ALTERATION TO A HISTORIC PROPERTY STAFF REPORT

Site:	46 Atherton Street	J. O. Frost - Swan Greek Revival Double House
Case:	HPC 2016.083, continued	Single Building Local Historic District Spring Hill National Register Historic District
Applicant Name:	Jeff Martinez & Annabel Realf, Owner	
Applicant Address:	46 Atherton Street, MA

Legal Notice: *Reconfigure front windows, doors; Replace windows on second floor to match ground floor; Add a deck on rear ell.*

CERTIFIED PLOT PLAN
 46 ATHERTON STREET
 SOMERVILLE, MA.
 (MIDDLESEX COUNTY)

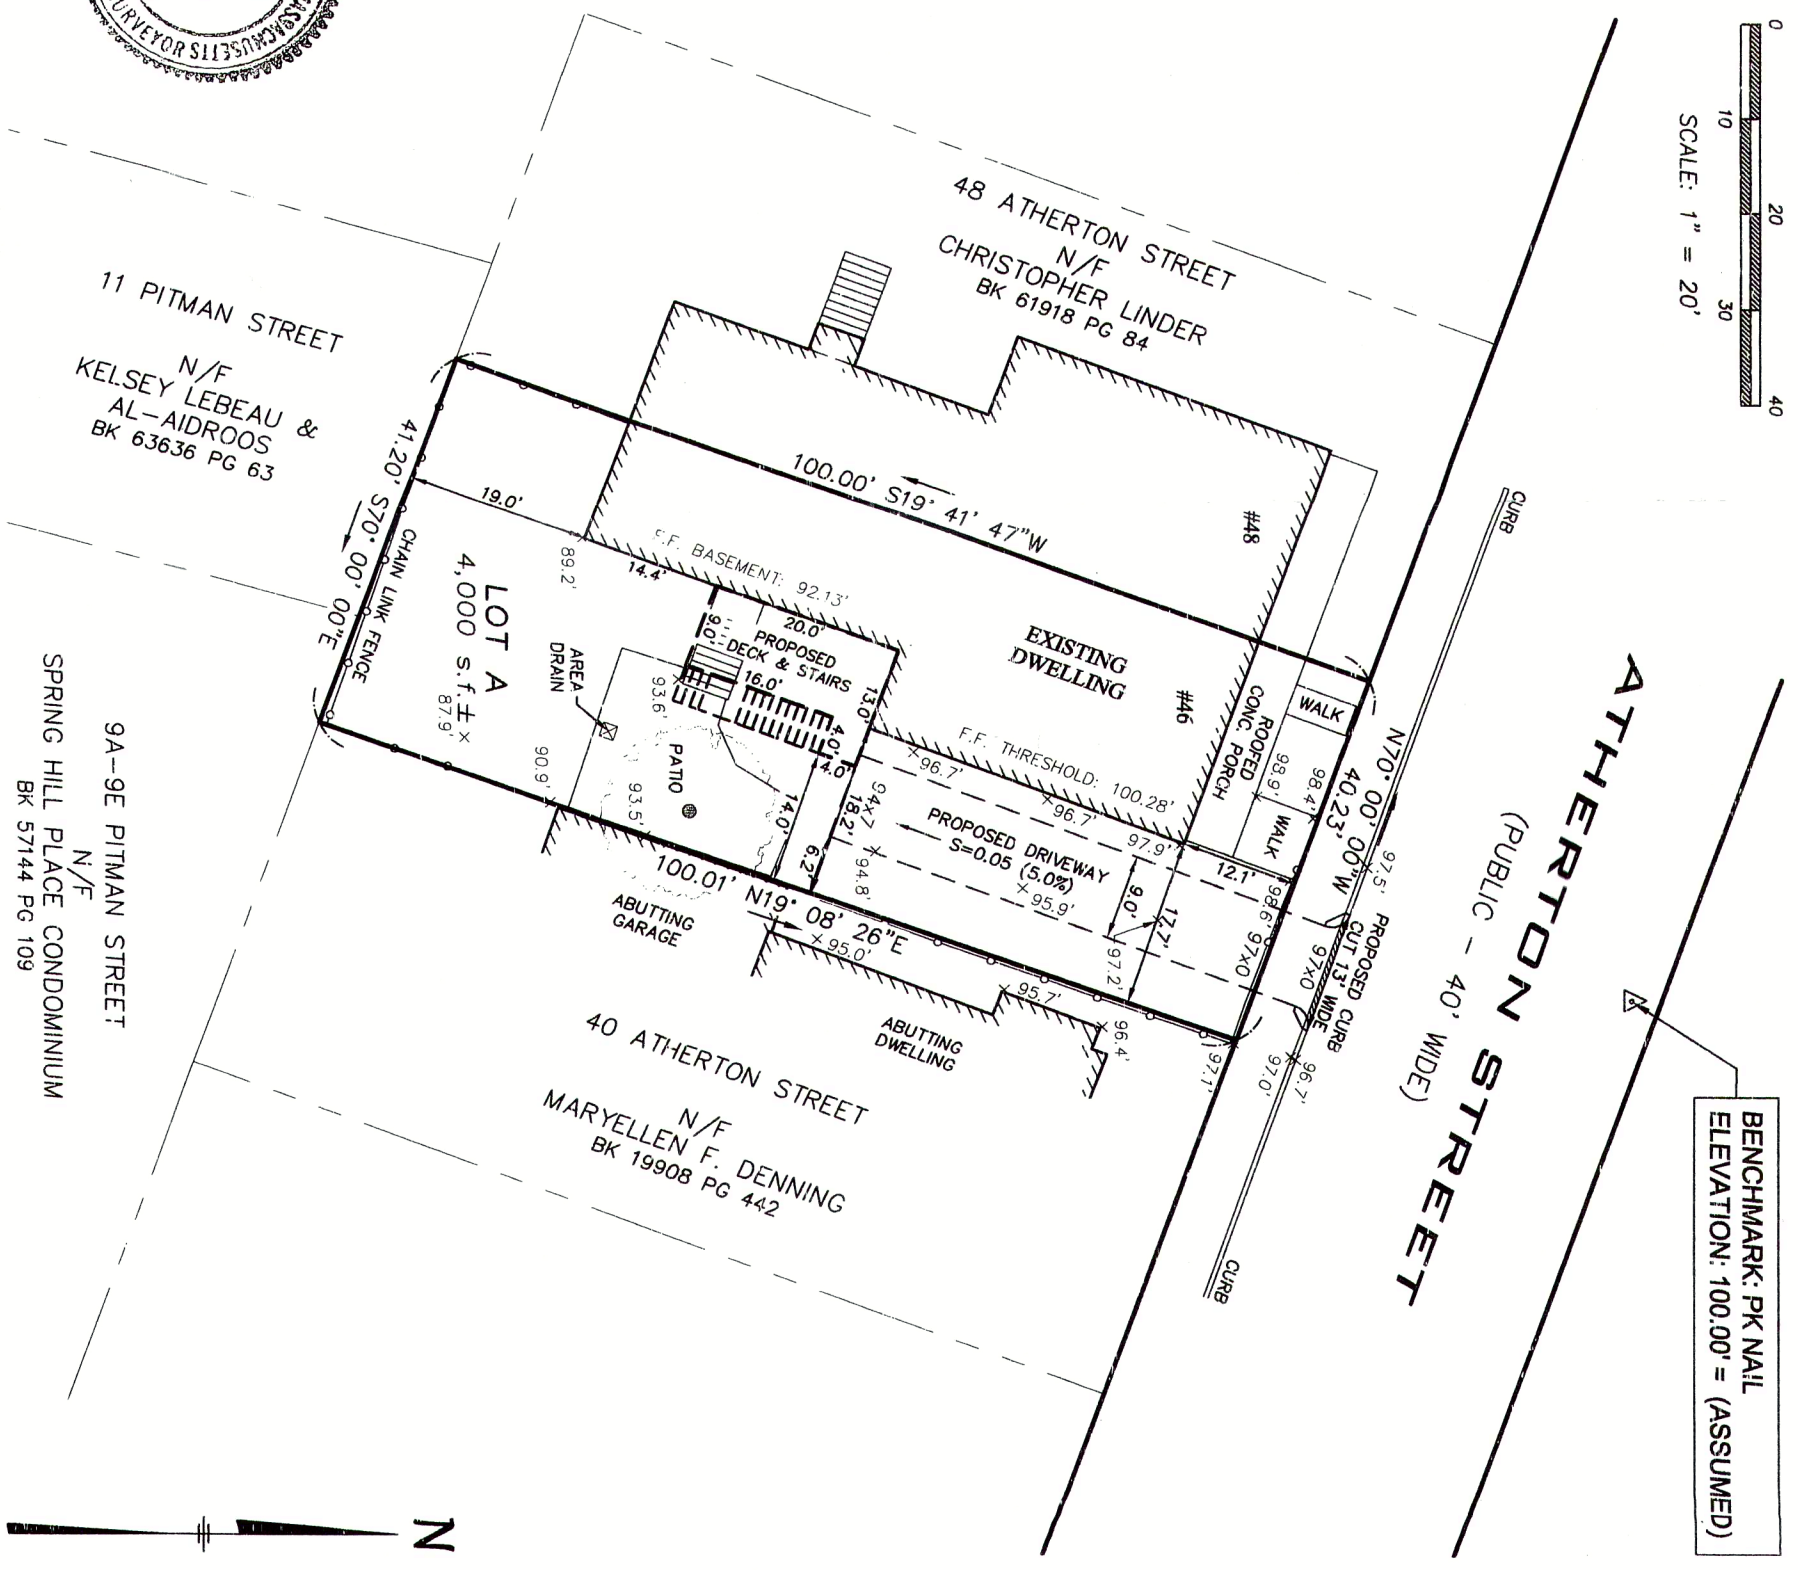
~~Design Guidelines do not address driveway material or location. The installation of a driveway is compatible with the historic district as the parcel evolves to accommodate other modes of transportation; the dimensions proposed are 9'.~~

~~The driveway would be located along the right side property line and would not alter any essential landscape features.~~

~~The surrounding environment has been significantly developed over the last hundred years. The addition of a driveway, approximately 9' wide, would be an appropriate transitional component of the landscape.~~

- ~~3. A 9' driveway providing tandem parking for 2 cars may be installed to the east of the building~~
- ~~4. The driveway material shall be constructed of concrete, 9 feet wide with 6' of green space between driveway and property line, and 3' of green space between the driveway and house~~

PROPOSED FIRST FLOOR

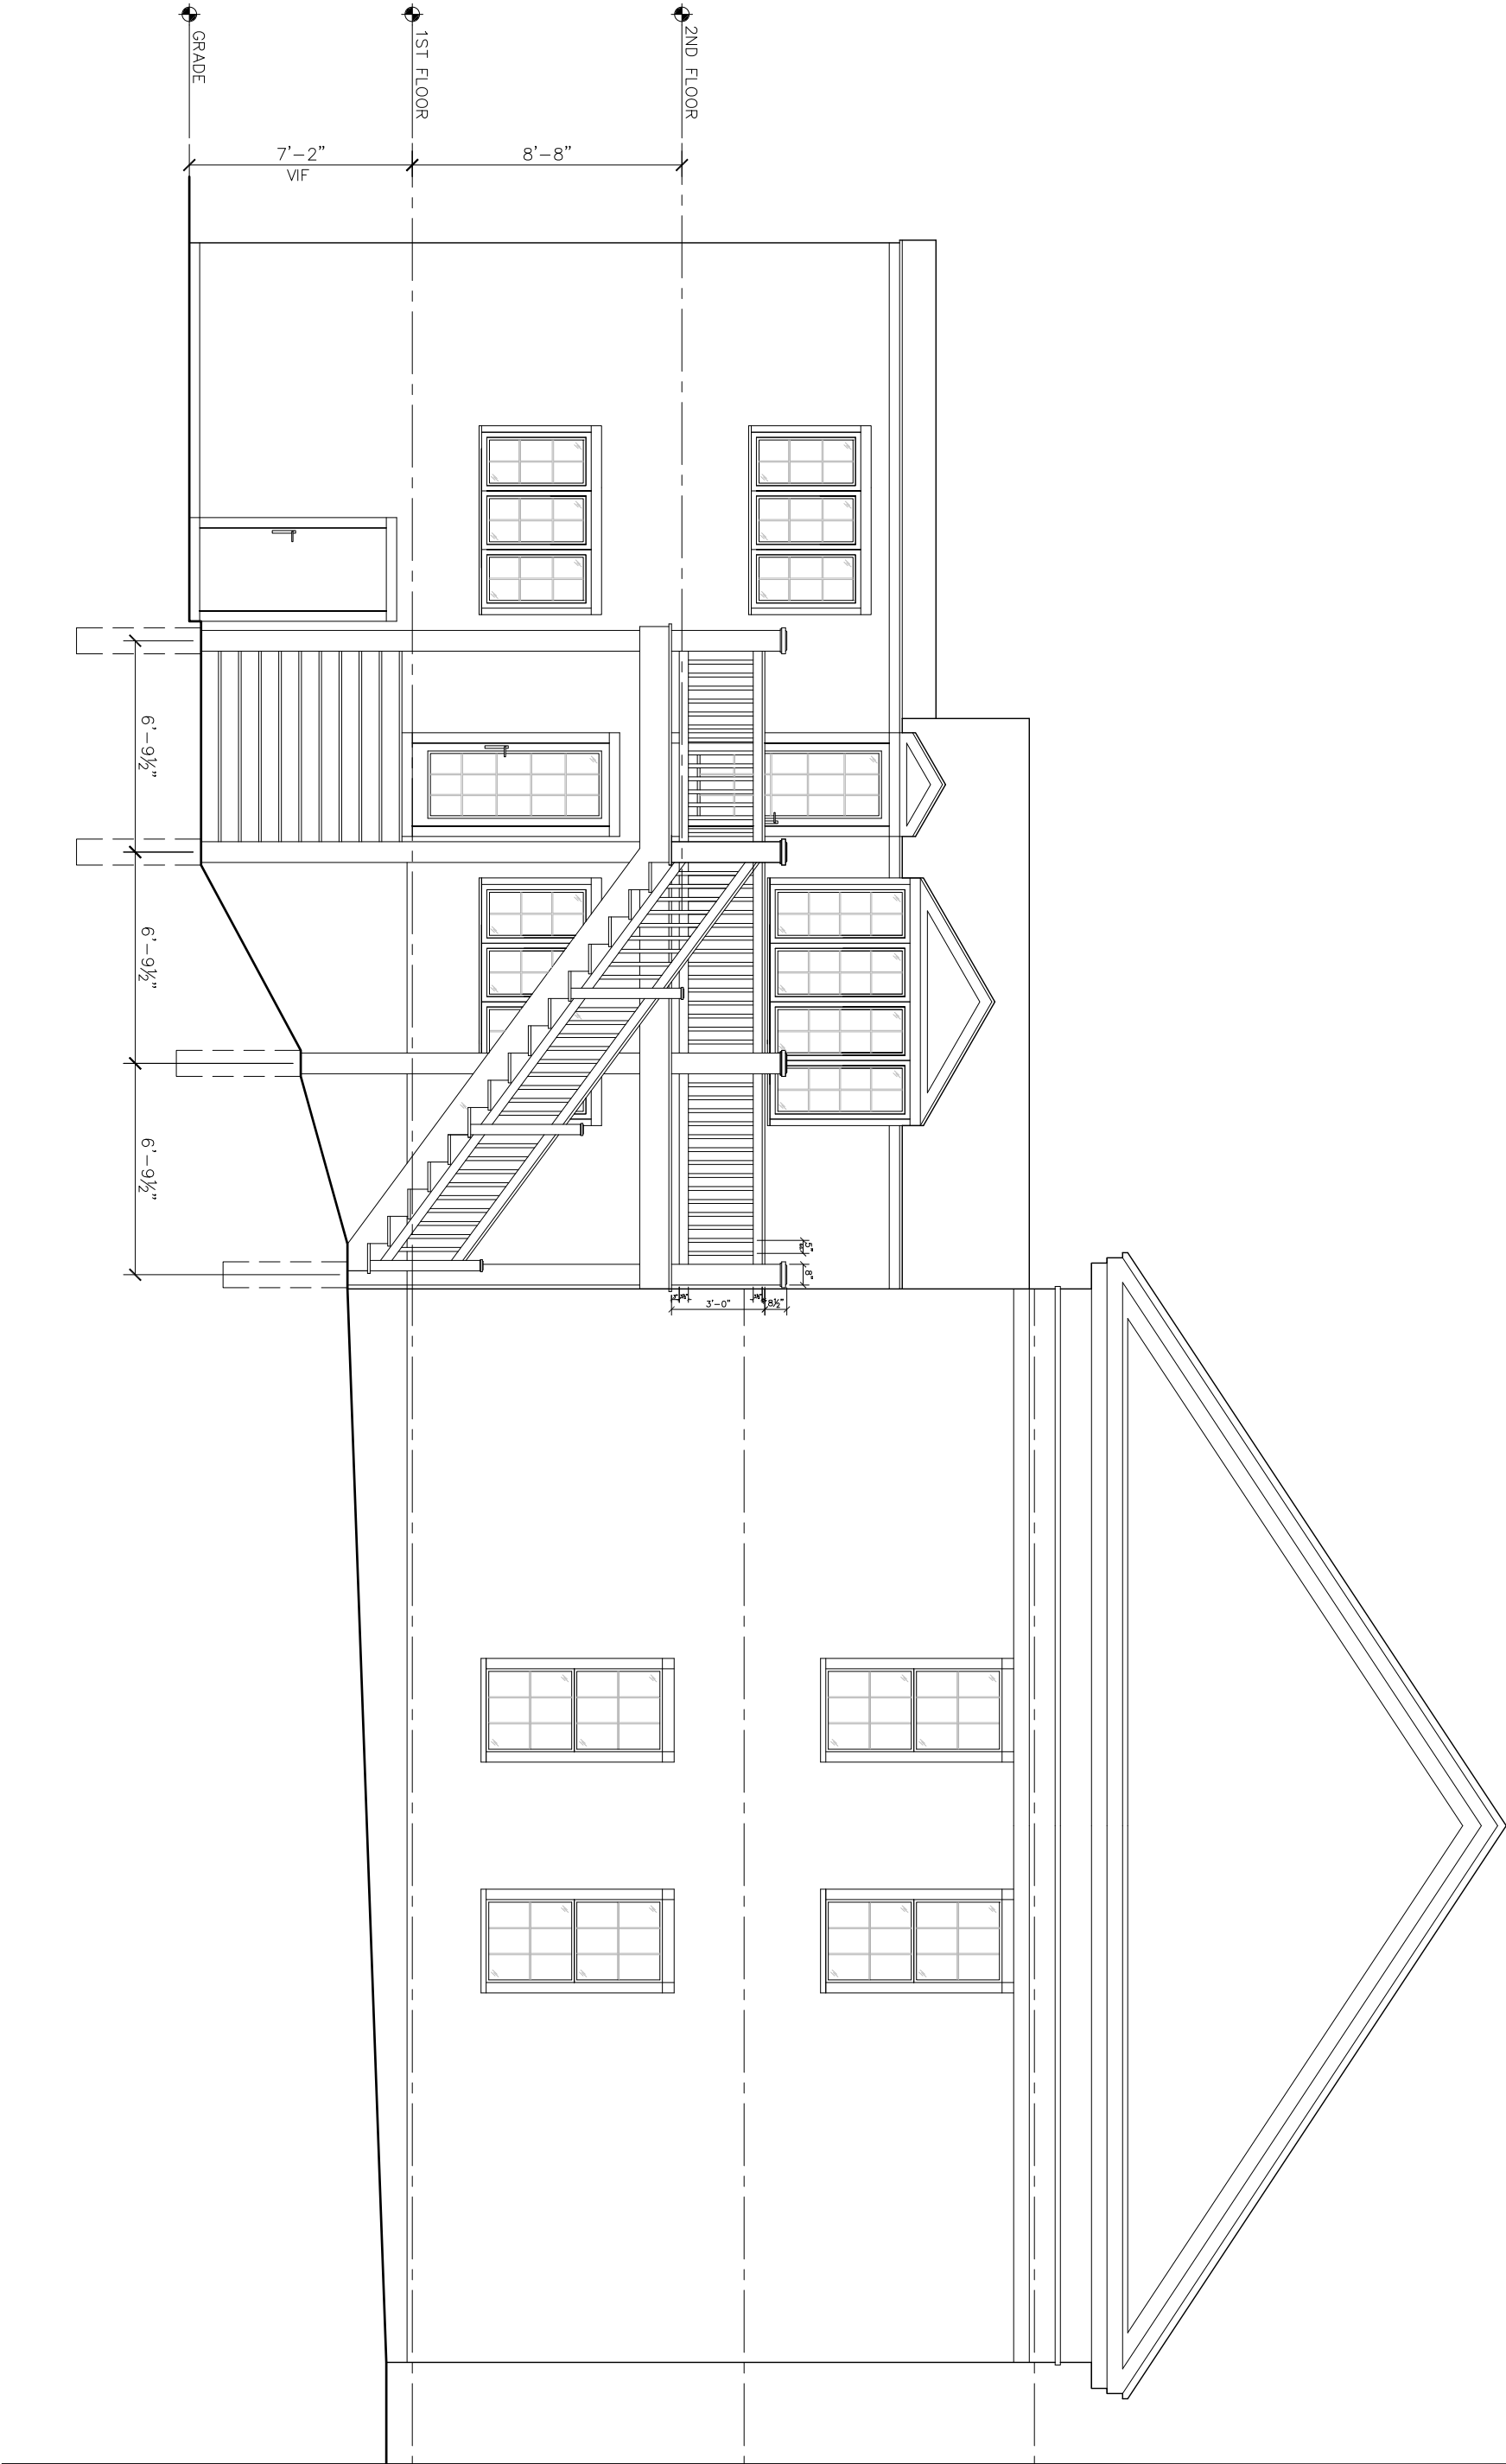
In order to correct a ceiling height issue in the addition, we will need to add two gables, one for the new door (not visible from public right of way) and one for the vinyl bay window (also not visible from the public right of way) The new gables would be trimmed and finished in the same style as the existing house.

We would also like to remove the vinyl bay window which does not match (see picture) and replace it with flat double hung windows, same style as the front. This window is not visible from the public right of way

PROPOSED
DECK ELEVATION

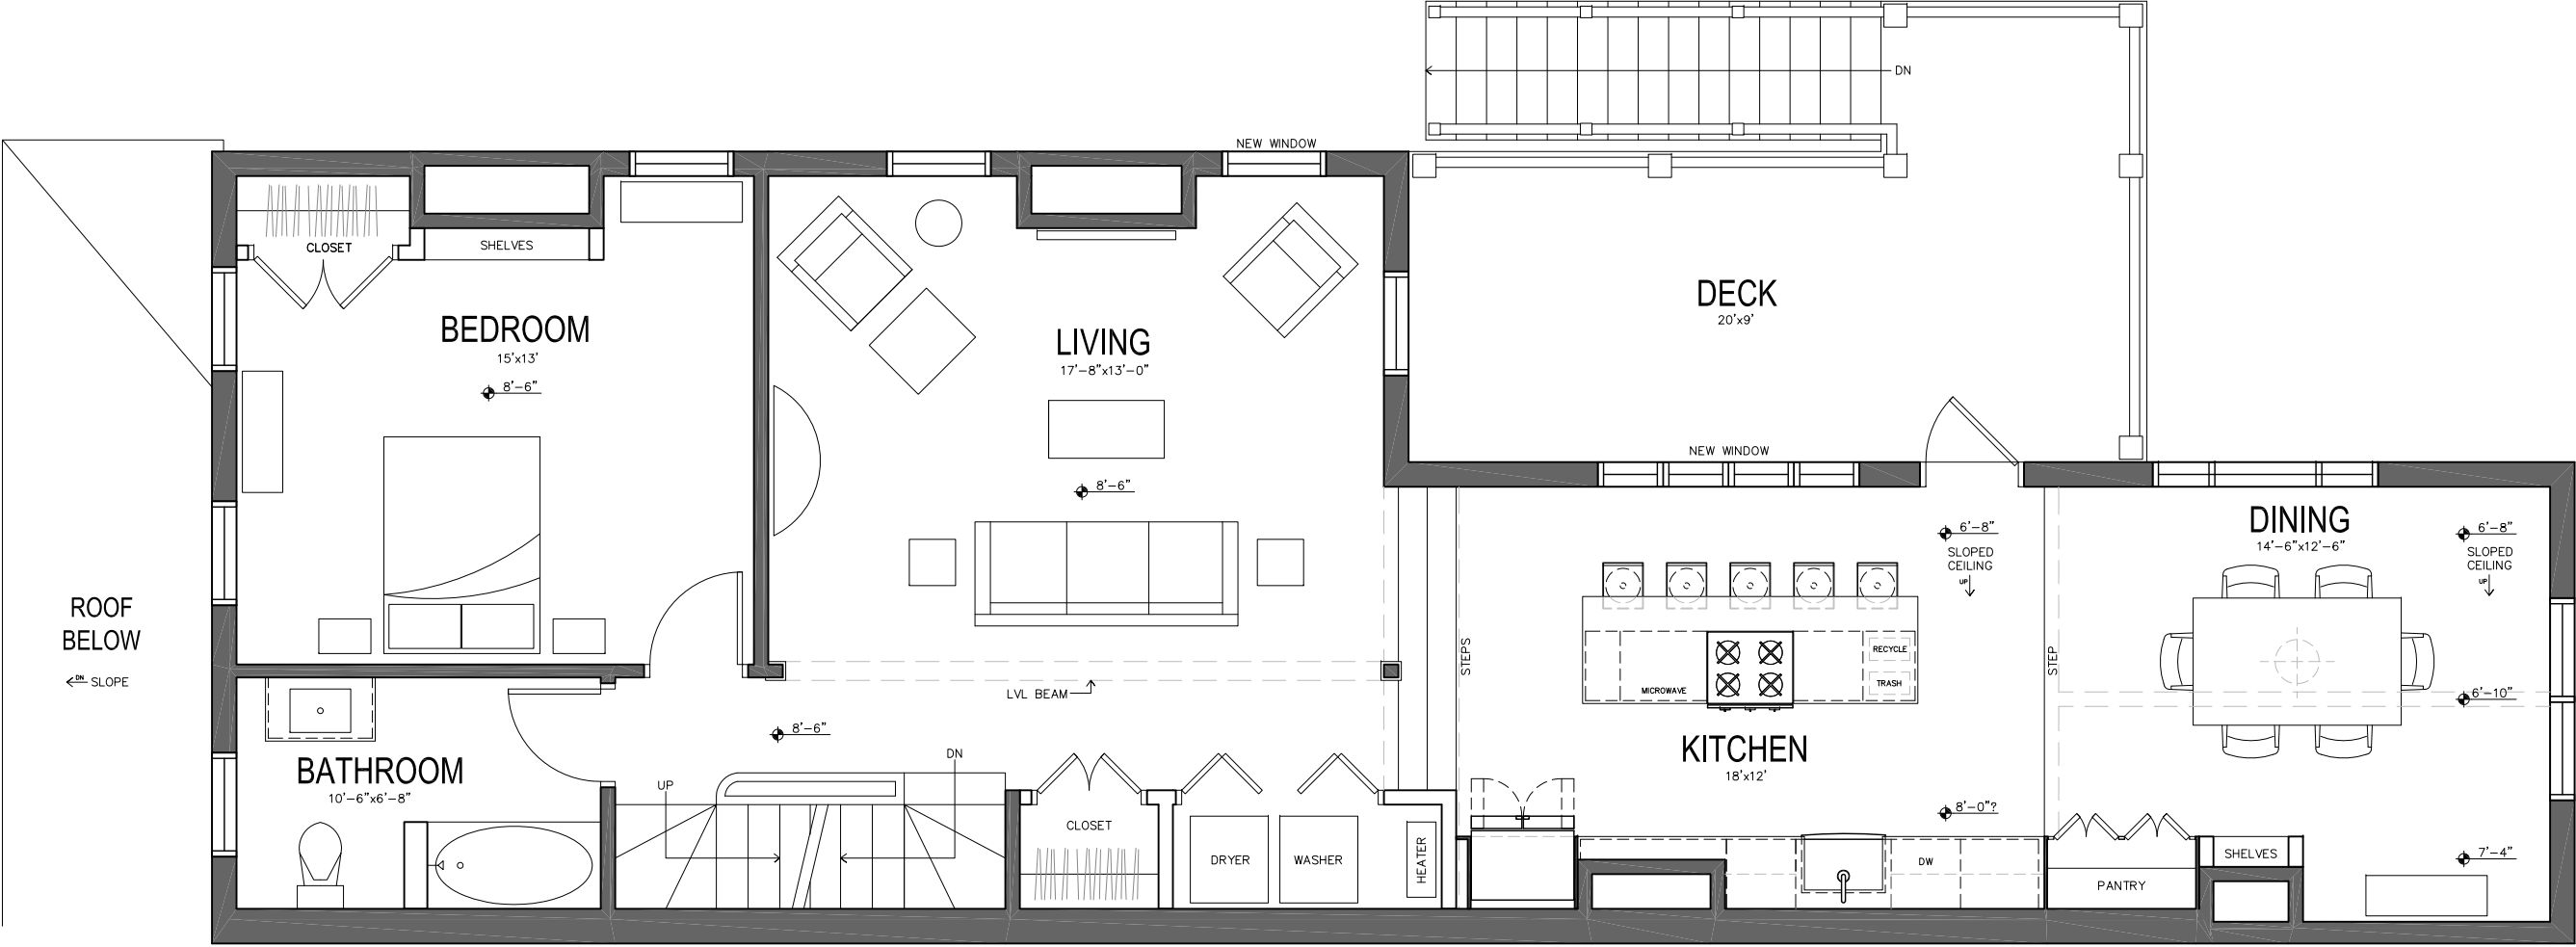
Deck: The Deck Is mostly hidden behind the ell of the house with the exception of the Staircase which would be visible from the street (if viewed directly from the front)

This would be a traditional style deck with large white columns, white trim, and lightly stained deck boards and stair treads (see example picture)

Deck will be finished with Ash, Cedar, Redwood, or similar rot-resistant finish grade lumber. Posts will be a minimum 6x6 square, wrapped in finish grade lumber and topped with a simple pyramidal cap.

Railing will be traditional style with 2x2 pickets, painted white. (see example picture)

Columns will be supported a minimum of 48" below grade, and attached to the house with a ledger board which complies with building code

- ~~5.3.~~ An egress and deck/ porch on the rear ell done in a classic style (see attached architectural drawings, and porch example).
 - a. The posts shall be no less than 6" square with simple toppers.

- b. The balusters shall be simple 2" stock.
 - c. The railings shall be of a generic style.
- ~~6.4.~~ Reconfigure front elevation to the original style:
